Re: Rapiscan AIT System Radiation Survey Reporting

Rapiscan A.T. CORP.	Secure 1000 Radiation Emission Measurement	FORM R-0646-1 (Single Pose)
-------------------------------	---	------------------------------------

**R-0646-1 Addendum
(Documentation Errors)**

Product Name	Secure 1000SP (Single Pose)
Serial Number	S51023011
Radiation Emission Measurement	Radiation Survey Dated: 11/17/2010
RSO Initials

2. Radiation Leakage Measurement: Survey Table. 2

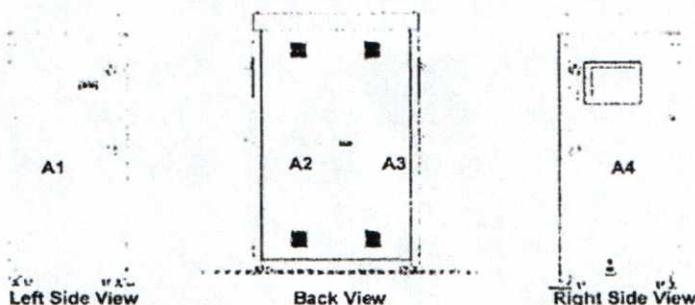
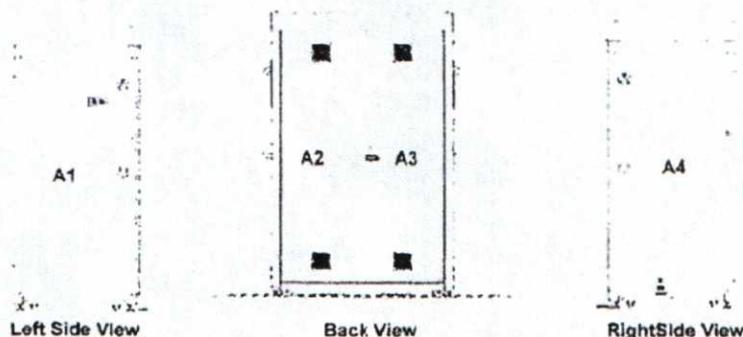
1. Low value indicated for background radiation. Typical values range from 7uRem/hr to 13uRem/hr at sea level. Note: Low value has no adverse impact on calculations.
1. TABLE 2: Incorrect presentation of data in Column 3 for Measured Exposure. Indicated value is .1 uRem. The correct value should be 1 uRem.
2. TABLE 2: Incorrect presentation of data in Column 6 for Dose Equivalent. Indicated value is .05 uRem. The correct value should be 1.8 uRem.
3. Technician did not print his name on survey report.

The service technician should attend refresher training.

The corrected data indicates this system was operating within expected parameters. No re-survey is required for this system.
